The Graduate Austin

Design Commission

December 11, 2023

Working Group Recommendations 11/8/2023

proposed lighting conditions

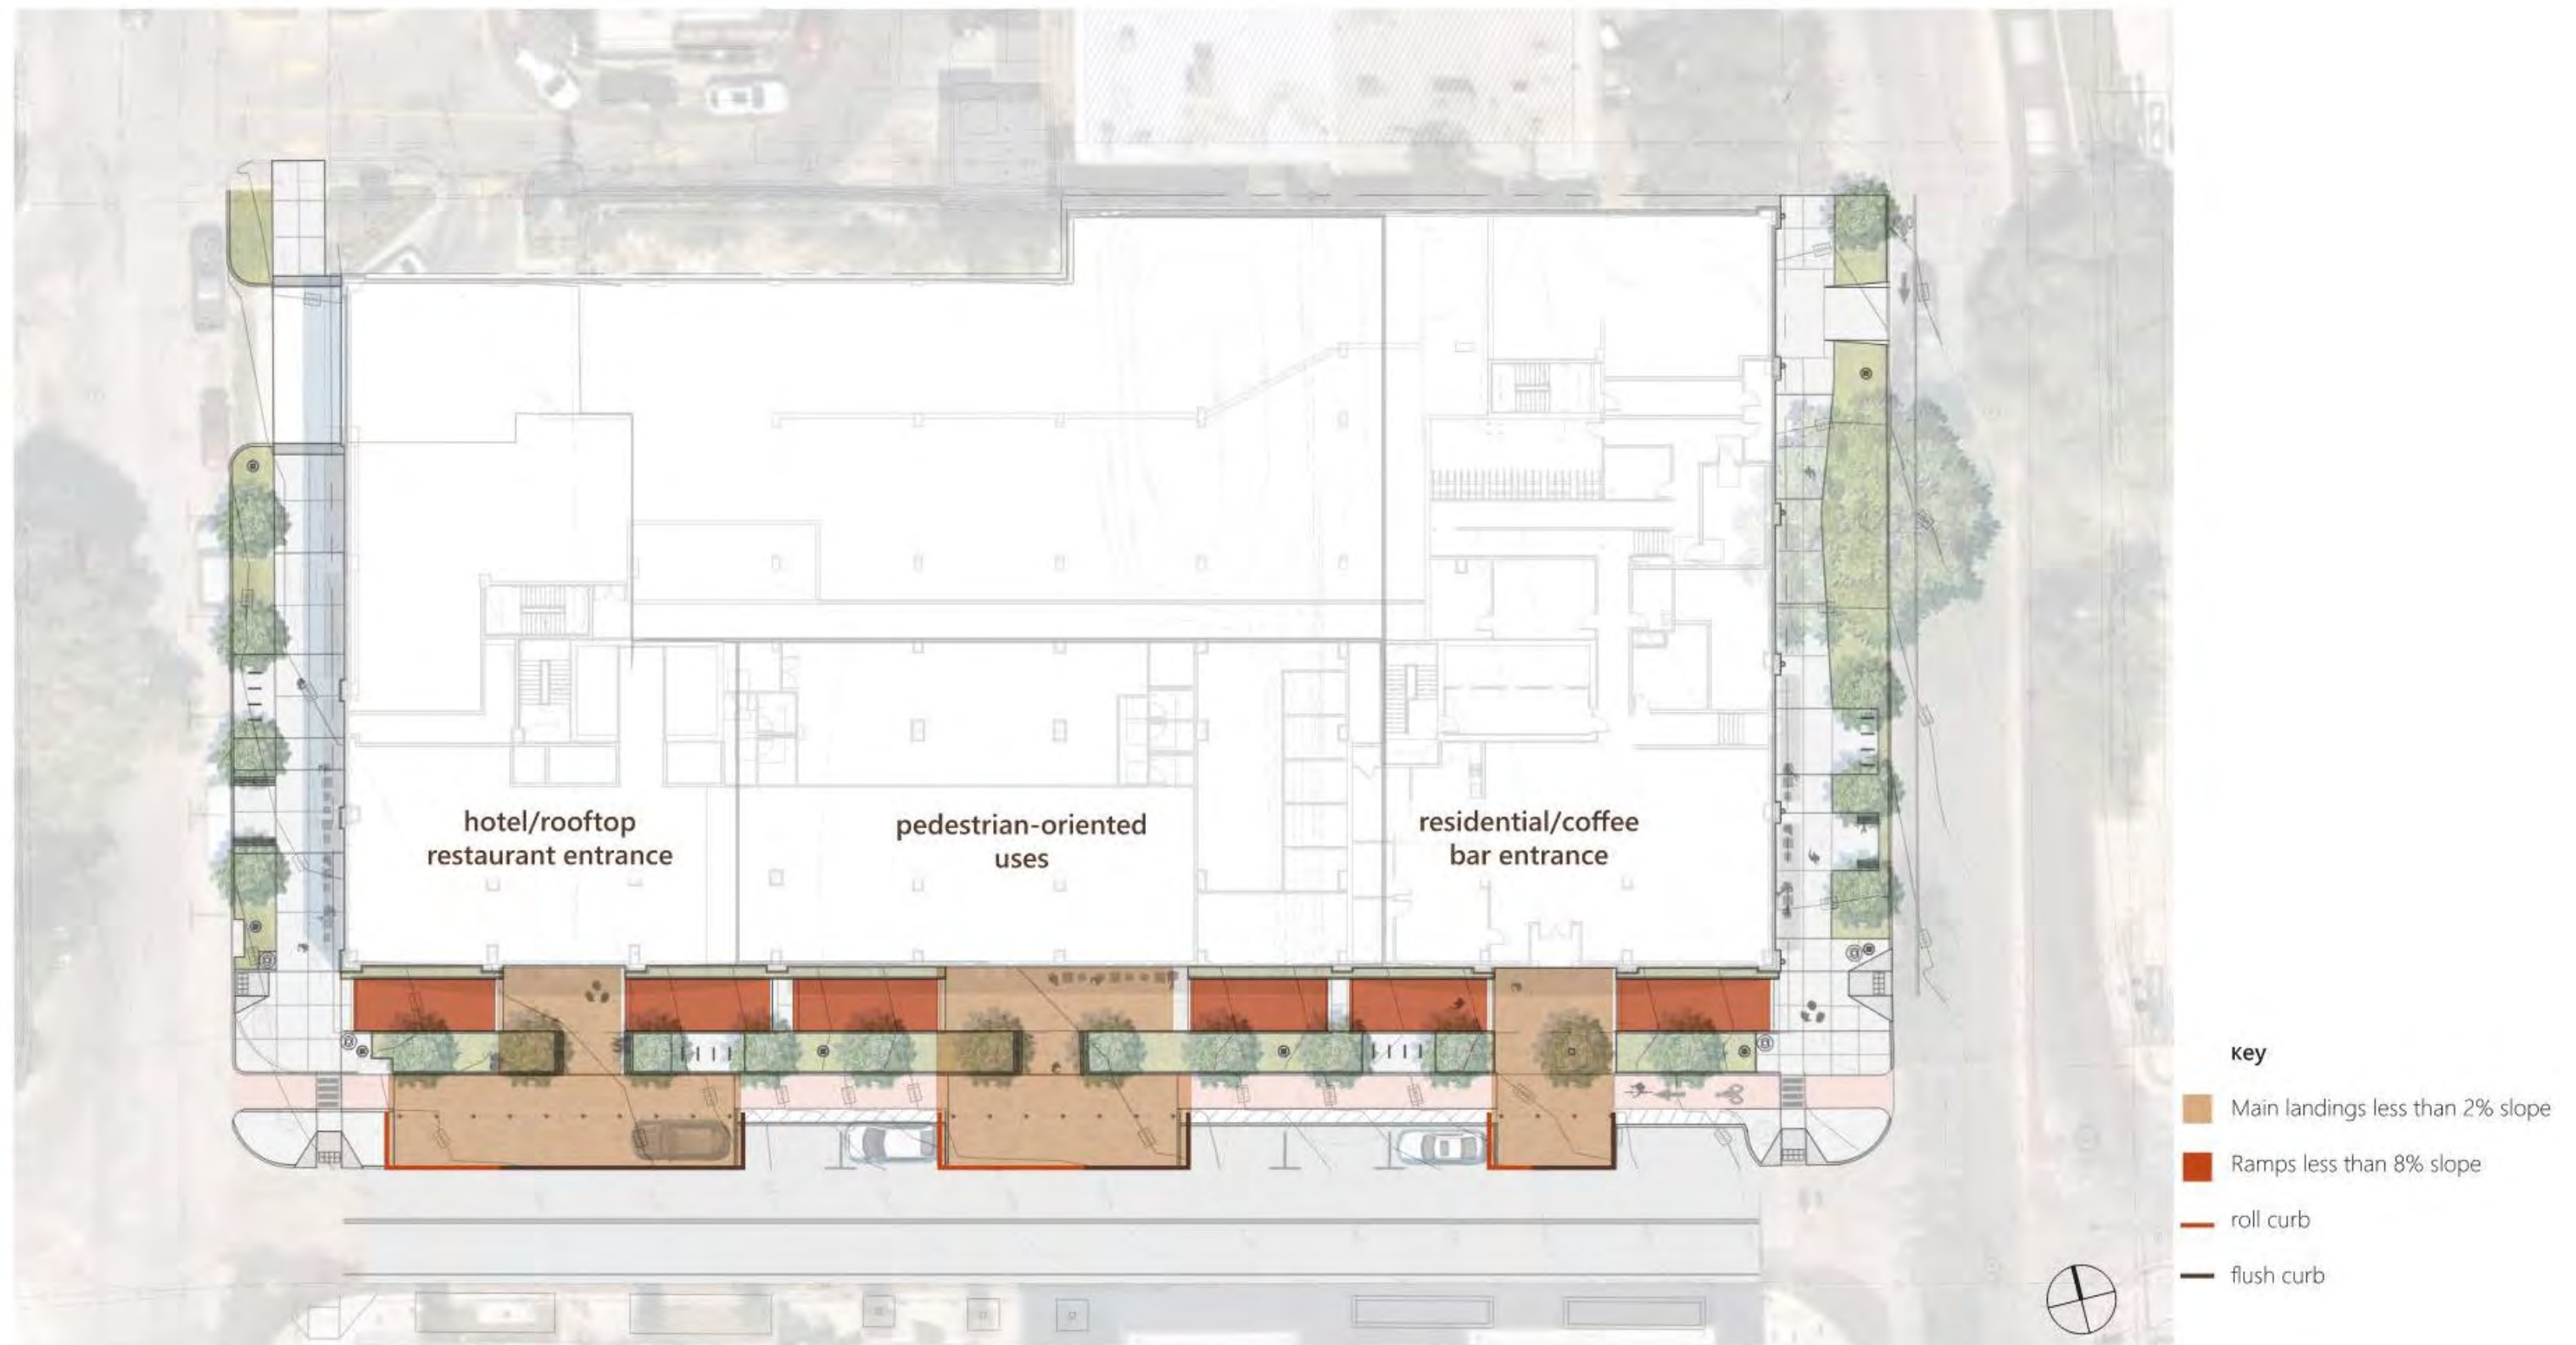
Urban Design Guideline	Working Group Recommendation
PZ 15: Increase Safety in Plazas Through Wayfinding, Lighting and Visibility	Provide more information on wayfinding that would direct public to upper level terraces. Access from hotel lobby to F&B for person's with disabilities not clear. Applicant encouraged to show route for clarity.

Ground Floor Plan – 1st Floor

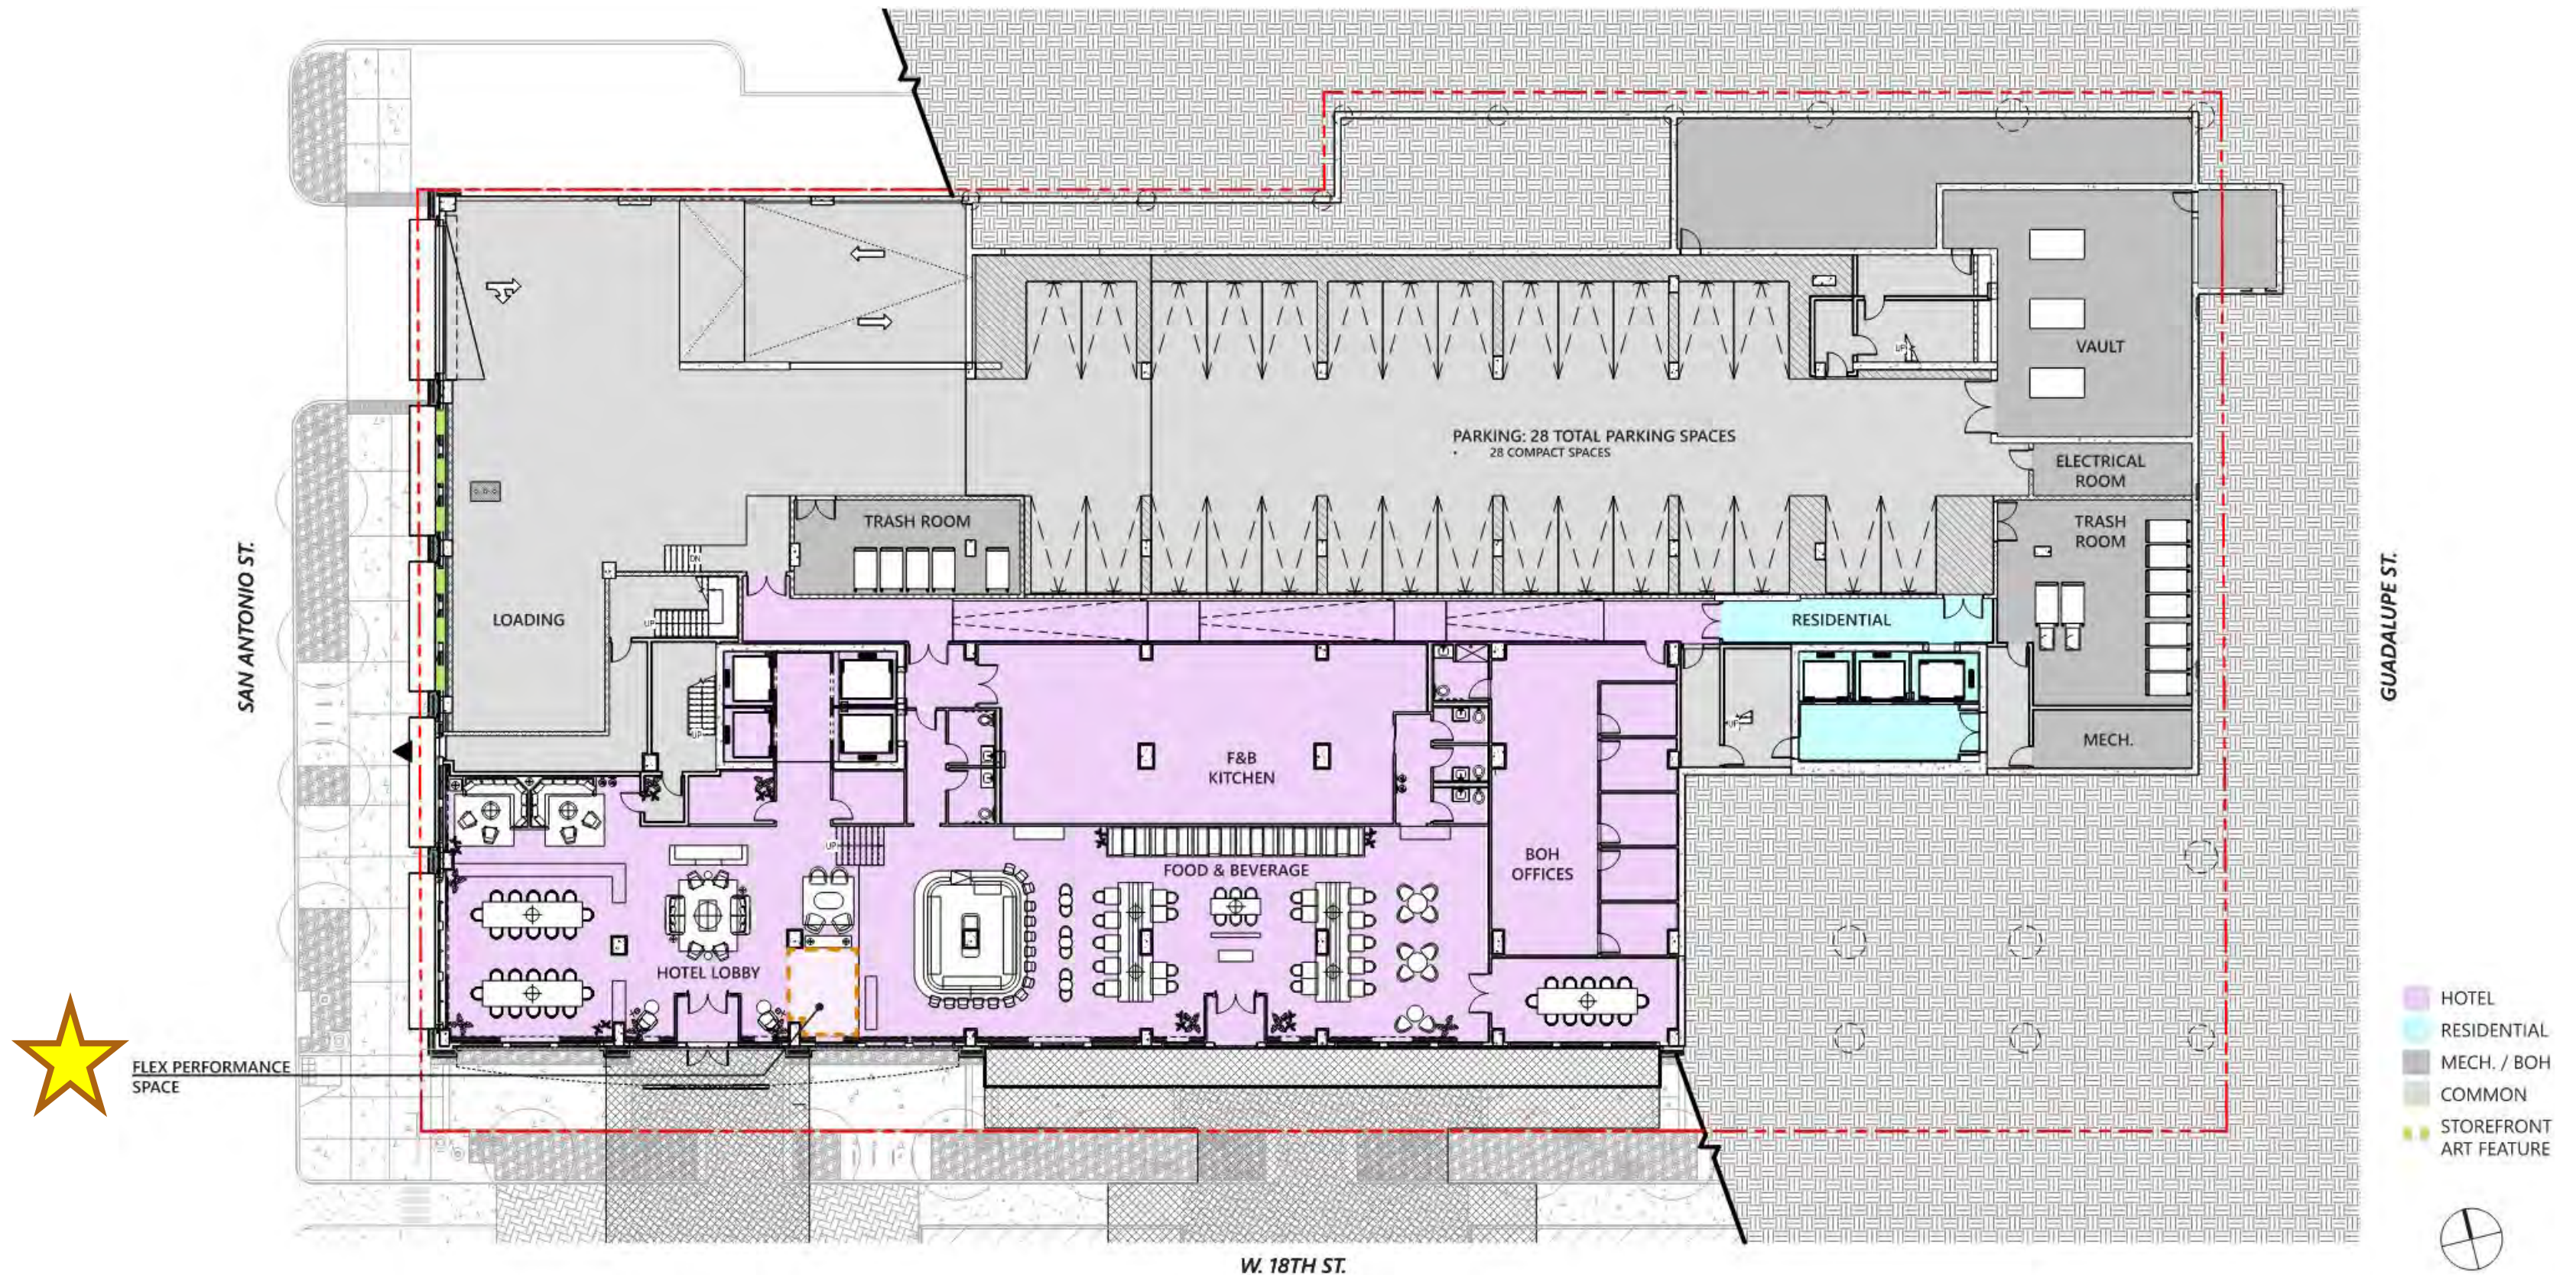
Urban Design Guideline	Working Group Recommendation
B 2: Provide Multi-Tenant, Pedestrian-Oriented Development at the Street	Only small portions of the frontage along San Antonio and Guadalupe have access to tenant spaces. The chairs and tables along San Antonio do not have direct access to hotel lobby. Hotel lobby doesn't indicate any active uses to support the table/chairs. Applicant is encouraged to activate the frontage along San Antonio and Guadalupe as much as possible.
